TESTS ON EXPERIMENTAL UNIT  
PROJECTION PLAN POSITION INDICATOR  
REPEATER, MODEL VG-2, SERIAL NO.X2,  
TYPE CG-55AFL.

FR-2547

Radio Division-Special Development  
Report No. R-2547-Problem S802T-C

On 4 September 1944, the experimental Model VG-2, Serial No. X2, Projection Plan Position Indicator Repeater, made by the General Electric Company of Bridgeport, Connecticut was delivered to this Laboratory for type test.

PLATE 1

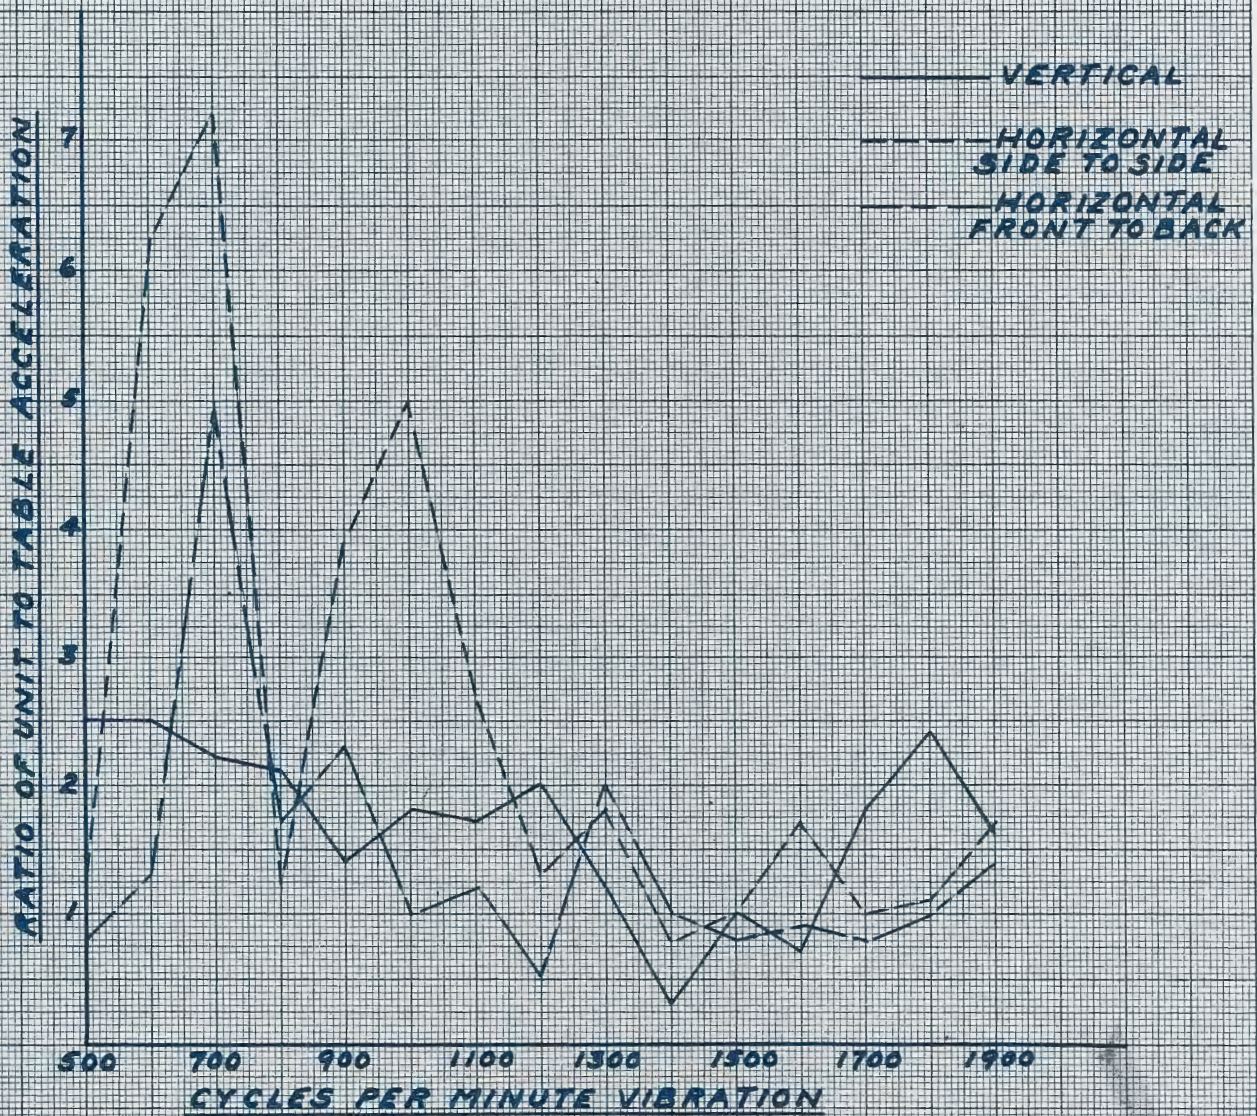
12. At the beginning of the test, the table was vibrated throughout the available range of frequencies, 500 to 1900 C. .M. During this cycle of vibration, a General Radio vibration meter, Type 761, Serial No. 224 was used so that ratio curves (Reference Plates 1, 2, 3, and 4) of table to unit displacement could be plotted. By means of this curve, the most serious modes of vibration could easily be determined.

13. The most predominant vibration modes were at 600, 900, and 1000 C.P.M. This can be seen by examining Plates 1, 2, 3, and 4. At 900 C.P.M. the top viewing screen has an amplitude of vibration of approximately 1/8 inch side to side and 1/16 inch vertical. During the vibration test, the end chassis panel rattled excessively.

- (b) (9) The failure of the unit when subjected to high humidity should be investigated and corrected.
- (c) (13) Some means of dampening the unit's resonant modes of vibration should be incorporated in the method of shock mounting the equipment. The vibration of the end chassis panel should be corrected.

5 PLATE

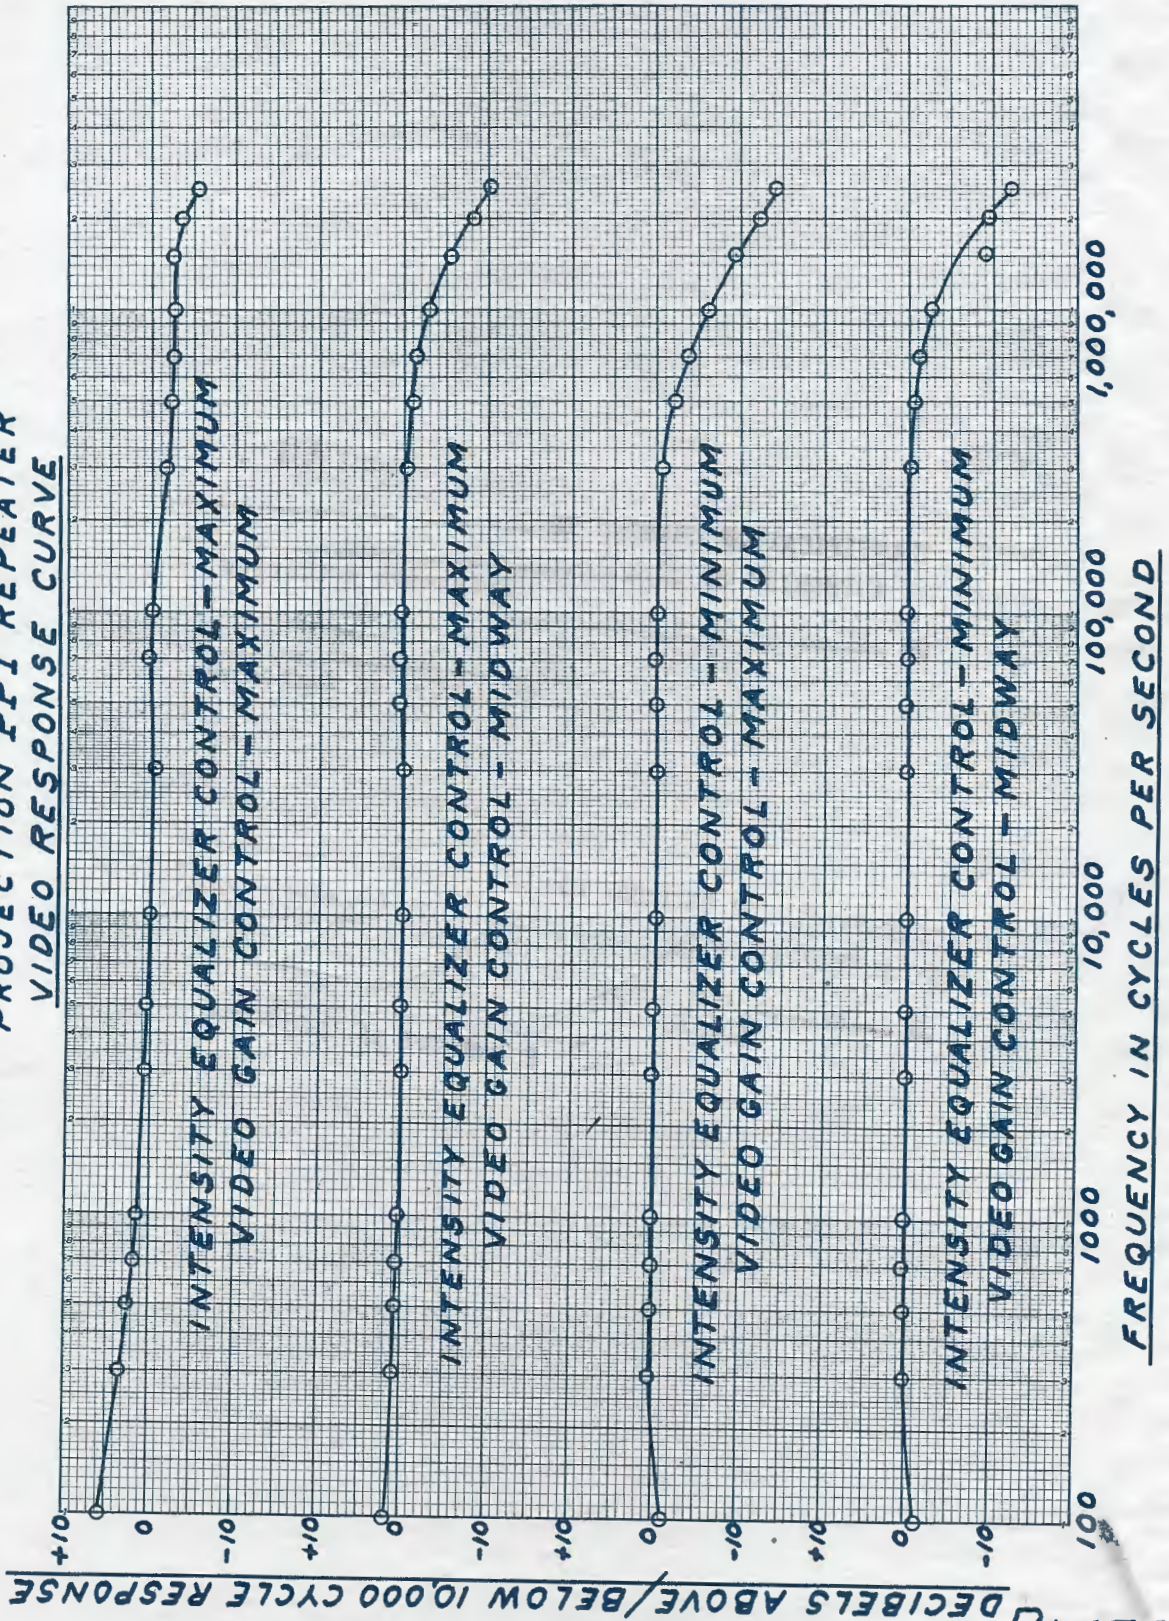
23. The magnitude of the output voltage delivered by the amplifier was measured when it operated with signal inputs of video frequency of an amplitude of one volt. Measurements were made with the video gain control set at maximum and midway with the intensity equalizer control set at maximum and minimum. The results obtained from the tests show that the output of the amplifier is not better than 1.0 megacycle wide at 3 db down but it is less than 3 db down at 10 kilocycles. (Reference Plate 5). The equipment does not fulfill all of the requirements of Paragraph 3-1(b) of Reference (c).

- (f) (23) The response of the video amplifier should be improved so that it meets the requirements of Paragraph 3-1(b) of Reference (c).
- (g) (28) The recovery time between the finish and start of consecutive sweeps is not sufficiently rapid on the eighty and two hundred mile ranges to meet the repetition rate requirements of Paragraph 5-5 of Reference (d). This should be investigated and corrected.
